United States Patent and Trademark Office

APPLICATION NO.	FI	LING DATE	FIRST NAMED INVENTOR	ATTORNEY DOCKET NO.	CONFIRMATION NO.	
10/658,300	09/08/2003		Eric Stephen Mattis	030296	2134	
23696	7590	09/09/2005		EXAM	INER	
Qualcomm Incorporated				PRESTON	PRESTON, ERIK D	
Patents Dep	artment					
5775 Morehouse Drive				ART UNIT	PAPER NUMBER	
San Diego, CA 92121-1714			2834

DETAILED ACTION

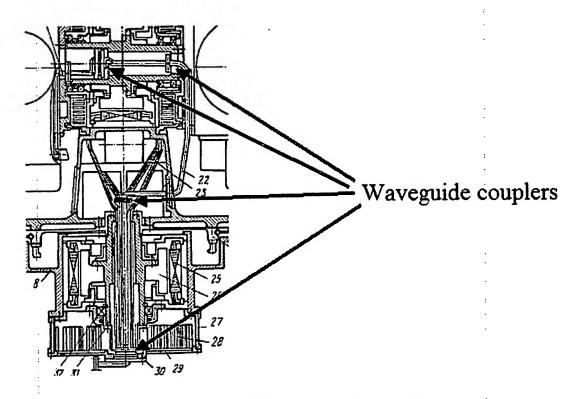
With respect to claim 8, Studer in view of Belyanskii teaches the apparatus of claim 7, wherein the shaft additionally comprises a waveguide coupler (See diagram bellow).
